air pollution control district
SANTA BARBARA COUNTY

Re: Conditional Approval of Revised 2018 Air Toxics Emission Inventory Plan UCSB Air Toxics “Hot Spots” Information and Assessment Act (AB 2588)

UCSB 2018 ATEIP Conditional Approval Items

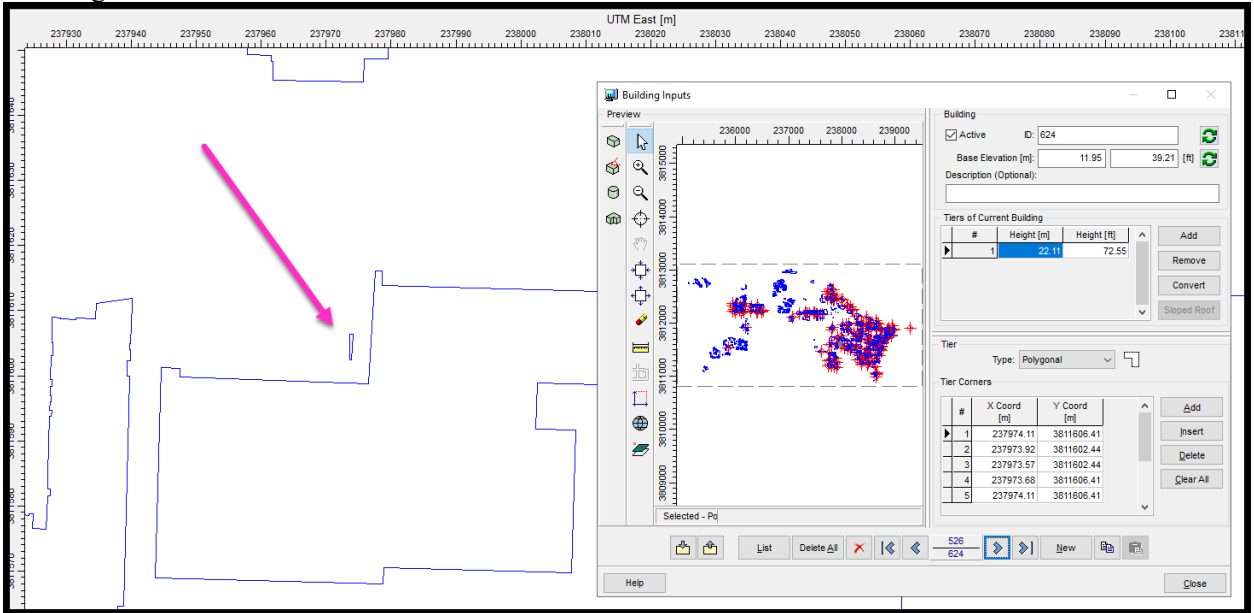
- d. Fine grid receptors covering most of UCSB were included in Appendix C. However, there are a few areas without a fine grid, including the San Clemente Villages and much of the West Campus and North Campus areas. Acute onsite receptors with a grid spacing no greater than 25 meters must be placed over any area accessible to the public. Onsite receptors are not required in fenced and gated areas that prohibit public access. Update the *Receptor Table* tab of Appendix C to include acute onsite receptors with a grid spacing no greater than 25 meters at all areas accessible to the public. If there are areas where onsite receptors are intentionally excluded, provide a map or aerial photo that highlights the portions where public access is prohibited due to fences and gates.

a. Building ID 624 is labeled as the Studio Theater.

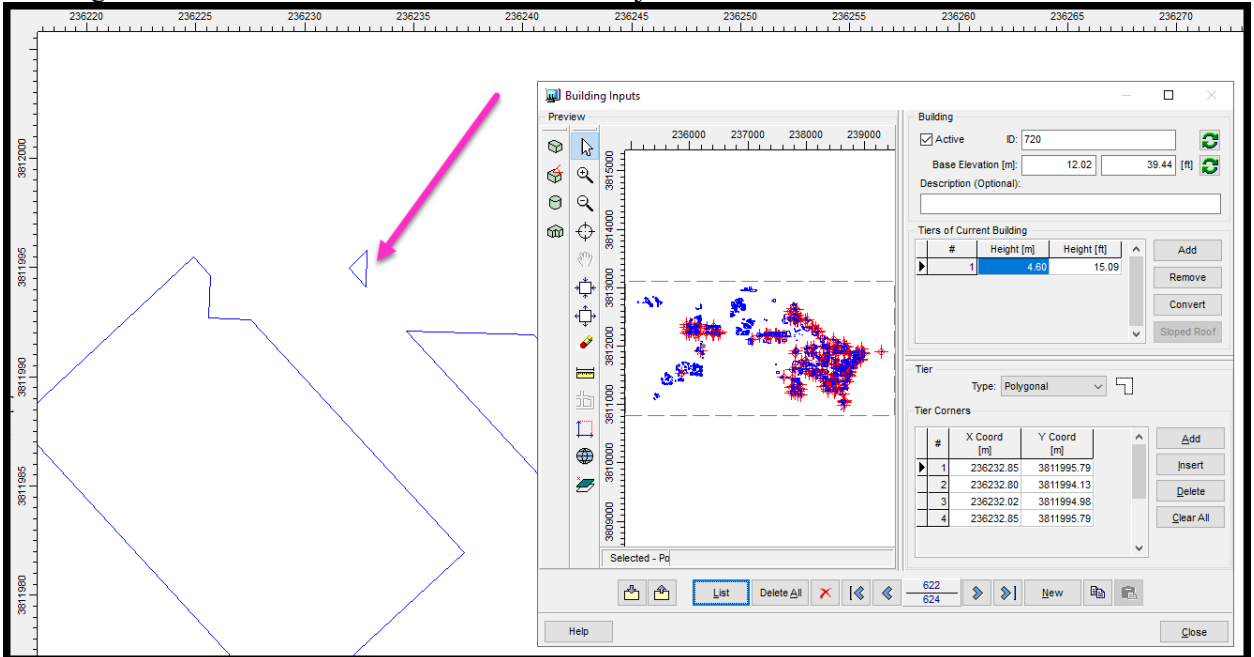
30. Building Shape (Appendix C). It appears there may be an error in the shape or size of three buildings listed below. See the screenshots below and revise the buildings' UTM coordinates in Appendix C as necessary.
